Engineering Observation Report

Project **Woodford Co. High School**
Emergency Structural Repairs

Project No. **2021-179**

Date Observed **June 8, 2022**

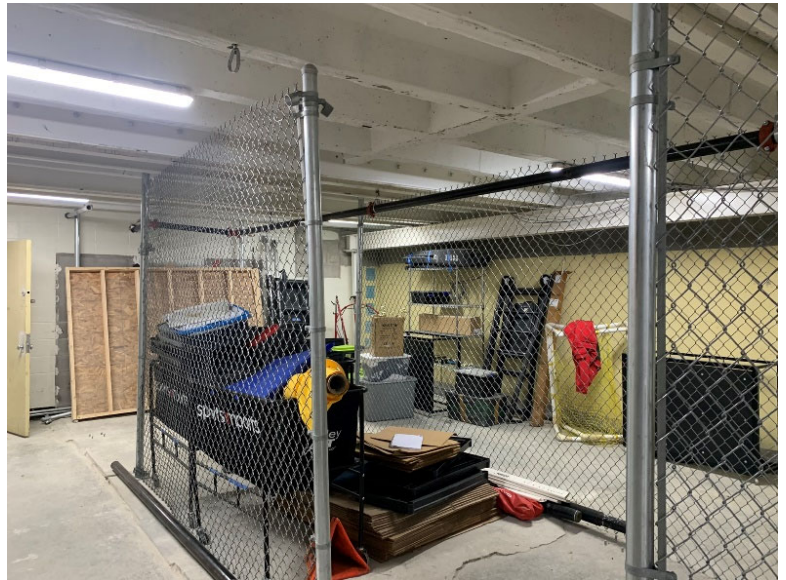
1. Please see the photos below. The new support framing and concrete infill was complete.

3. Refer to the photo on the left below. The channels have been welded to the supporting beam. It is not a structural concern, but the Architect should review the aesthetics of the welds.

4. See the photo on the right above. The Contractor did not install the screw anchor at mid-span where the stiffening infills were removed. It is structurally acceptable to leave one screw anchor out at each side of the concrete joist at this location.
5. In general, the project appears to be going well.
